BOARD OF ZONING APPEALS

Z19-15

333 Foundry

Subject: A Variance request from Section 1147.10(f) of the Planning and Zoning Code to permit a 108 square foot, 6 foot tall sign on the building roof when a roof sign is strictly prohibited.

FOUNDRY

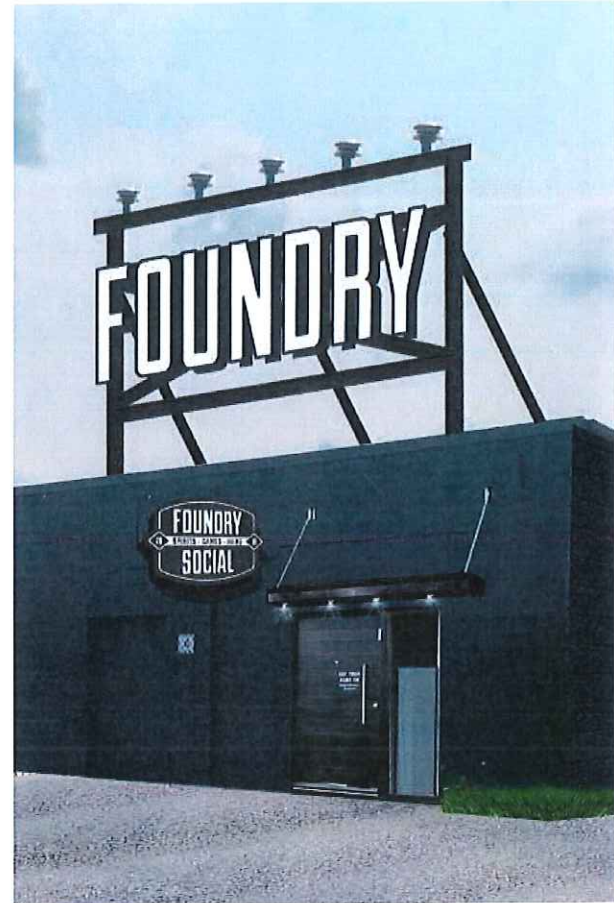
Mr. Mendel stated the proposed roof sign is 6 feet tall (above the roof), 108 sqft and located on the northeasterly corner of the building. Roof signs are specifically prohibited.

Mr. Mendel stated he proposed roof sign may impact the character of the site and/or neighborhood due to its prominence and visibility.

There was a lengthy discussion about the size of the roof sign and how it looks from different vantage points in the area. Mr. Mendel stated the roof sign is proposed to be uplit or downlit from exterior lights and not internally illuminated. Mr. Cordray stated the light will be just enough to see it and not illuminate a large area. Mr. Cordray stated it can be dimmed down also. Mr. Roszak asked the hours the sign will be lit. Mr. Cordray stated the sign would be lit only when the operation is open, approximately Friday and Saturday until 11:00pm. Mr. Williams stated it could be as late as 2:30am according to the liquor license obtained. Mr. Cordray stated they are willing to shut the light off and he does not want it to disturb the neighbors at all.

Mr. Henwood asked how far the roof sign is set back from the right of way. Mr. Mendel stated it is 193 feet from the west curb of Foundry Street.

Mr. Humpal stated he has difficulty with the roof sign after hearing comments from area residents this evening. Mr. Henwood stated he has difficulty with the roof sign because it is not permitted, period. Mr. Henwood stated he will not vote to approve the roof sign. Mr. Roszak stated he is excited about the signage and he is not opposed to the signage. Mr. Henwood stated he would like to see a proposed compromise from the applicant. Mr. Cordray stated he will do whatever is best for the community. Mr. Henwood asked the applicant if he would consider a smaller sign. Mr. Cordray stated yes. Mr. Cordray stated if it is scaled down, it does not look in proportion to the building size. Mr. Mendel showed an alternative roof sign rendering which was smaller, approximately 12 feet long.

Mr. Roszak stated he thinks the roof sign is in scale with the building and suggested the applicant to come back with photos from other distances and sizes and table the roof request. Mr. Cordray stated he is happy to do that. Mr. Williams stated he does not like the smaller sign proposal for the roof. Mr. Cordray requested to table the request for the roof sign variance until the October 10th meeting.

Foundry Roof Sign
as seen from the
park.

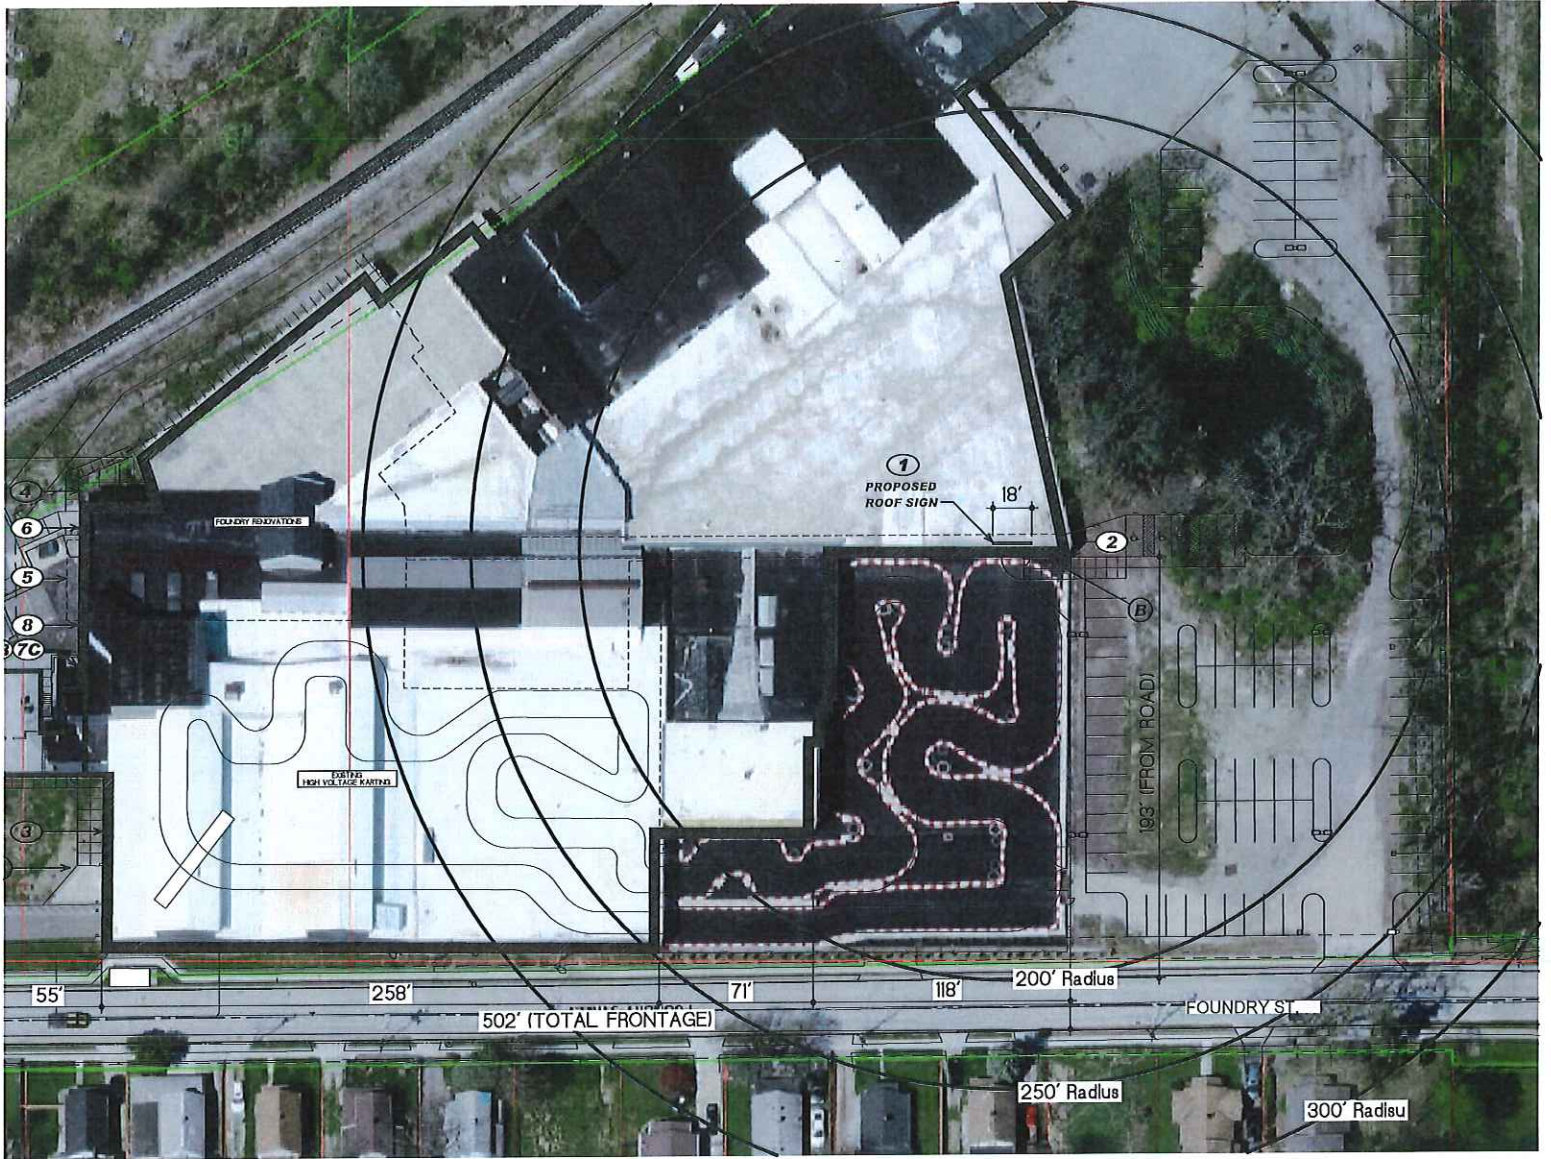
Mr. Cordray stated the smaller sign is not in scale with the building.

SPIRITS • GAMES • HANG

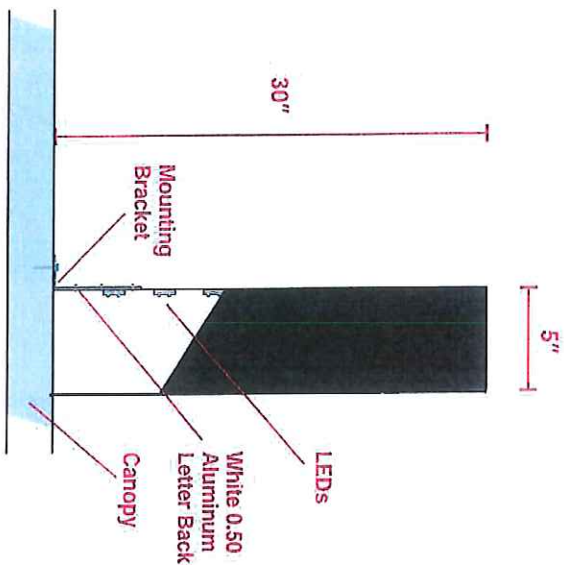
Mr. Henwood stated the "Spirits, Games, Hang" has been stated by Mr. Cerny as an architectural feature and not a sign. Mr. Henwood stated that is nonsense. Mr. Cordray stated he agrees.

Mr. Henwood stated the "Spirits, Games, Hang" sign is low hanging fruit. Mr. Cerny stated he disagrees. Mr. Roszak stated it identifies the purpose of the building.

VIEW OF FOUNDRY FROM MEDINA STREET

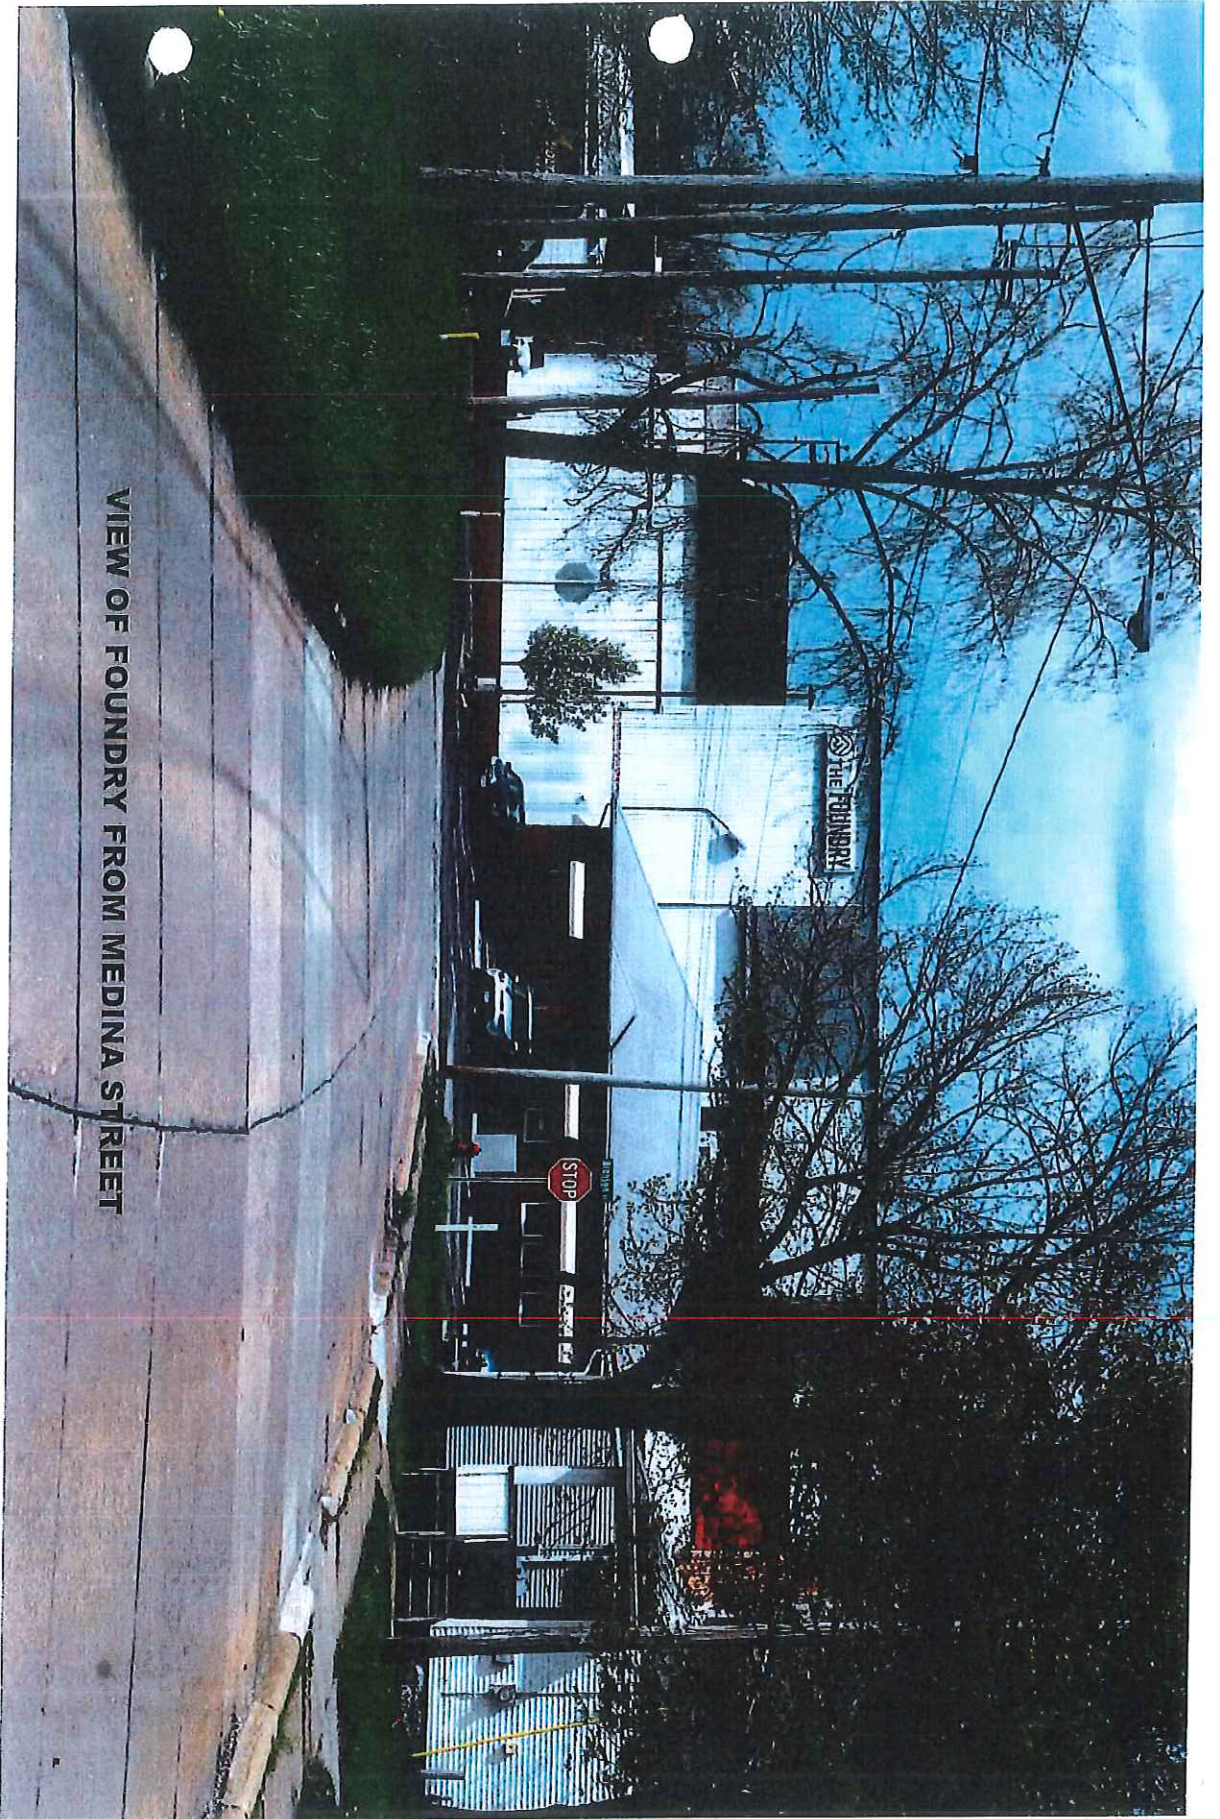
Mr. Henwood asked for an image of what can be seen from Medina Street as approaching the facility. Mr. Mendel put the image on the overhead projector.

There was a brief discussion around the photos of the site from different distances.
